Access Compliance Report

Public Rights-of-Way

Intersection ID: 49003	Main Street: STEELE_CREEK_RD	Cross Street: STEELECROFT_PY	Location: SW
ADA ID: 7EAD9E2E64C1	Ramp Type: Perp	Initial Pass/Fail: Fail	Overall Compliance: No
		Severity Score: 10

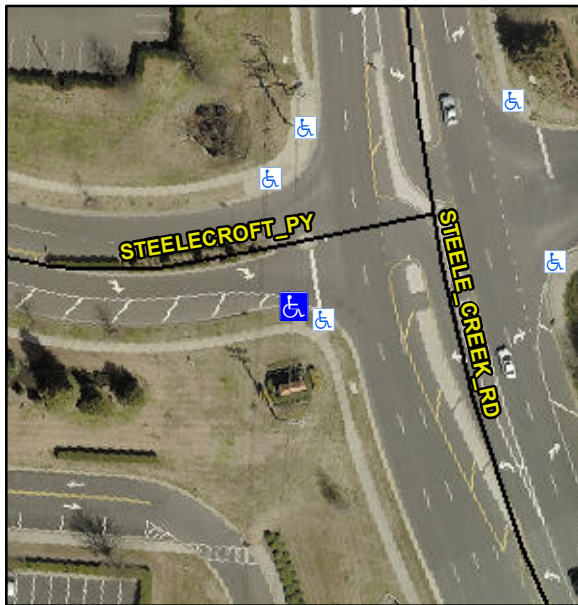
Not Found, R304.5.1, R304.5.3

Compliance	Description	Data	Compliance	Description	Data
N/A	Ramp Length (in)	95.5	Yes	Ramp Slope (%)	5.5
No	Ramp Width (in)	46.5	No	Ramp XSlope (%)	2.4
N/A	Flare Type LT	N/A	N/A	Flare Type RT	N/A
N/A	Flare Slope LT (%)	N/A	N/A	Flare Slope RT (%)	N/A
N/A	Flare Traversable LT?	N/A	N/A	Flare Traversable RT?	N/A
N/A	Landing Length (in)	N/A	N/A	DWS Provided?	N/A
N/A	Landing Width (in)	N/A	N/A	DWS Contrast?	N/A
N/A	Landing Slope (%)	N/A	N/A	DWS Length (in)	N/A
N/A	Landing X Slope (%)	N/A	N/A	DWS Full Width?	N/A
N/A	Landing Curb? (Y/N)	N/A	N/A	DWS Offset (in)	N/A
N/A	Shared Landing?	N/A			
N/A	Gutter Ponding?	N/A	N/A	Gutter Slope (%)	N/A
N/A	Gutter Lip Ht (in)	N/A	N/A	Gutter X Slope (%)	N/A
N/A	Painted X Walk1?	No	N/A	Painted X Walk2?	N/A
	X Walk 1 Direction	To N		X Walk 2 Direction	N/A
N/A	X Walk 1 Width (in)	N/A	N/A	X Walk 2 Width (in)	N/A
	X Walk 1 Slope (%)	2.9		X Walk 2 Slope (%)	N/A
	X Walk 1 X Slope (%)	1.5		X Walk 2 X Slope (%)	N/A

Remove & Replace Entire Ramp.
